Bicycle Infrastructure on Mathewson Lane

Sharrows Implementation in West Houston

July 22, 2020 Bicycle Advisory Committee
Regarding Agenda Item 6 - Presentation on Crashes Involving Cyclists in 2020

Bicycle Infrastructure on Mathewson Lane

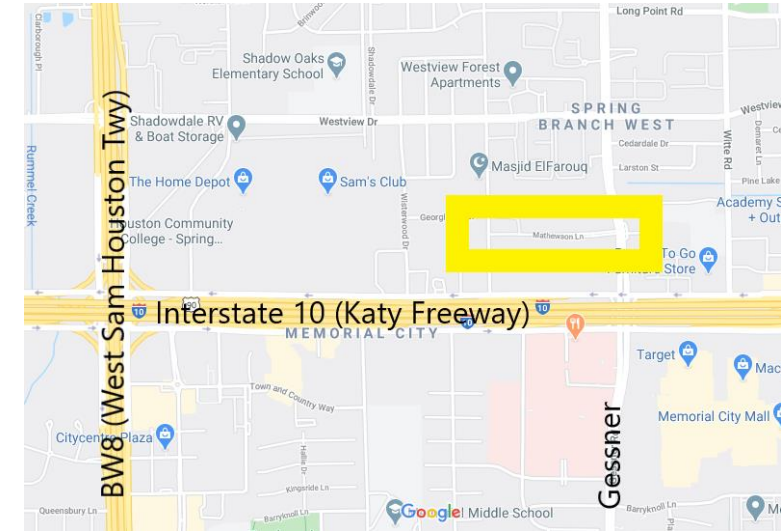
- Bike lane places inexperienced cyclists in hazardous door zone.
- Possible options to avoid this hazard in future:
 - 25 mph posted instead of 30 mph and mark as “Bikes May Use Full Lane”.
 - In west section (assuming ROW was limited):
 - No on-street parking.
 - In east section:
 - Smaller/no median.
 - No on-street parking.

- Inexperienced rider will be in door zone.

- Experienced rider would take lane or use far left side of lane.
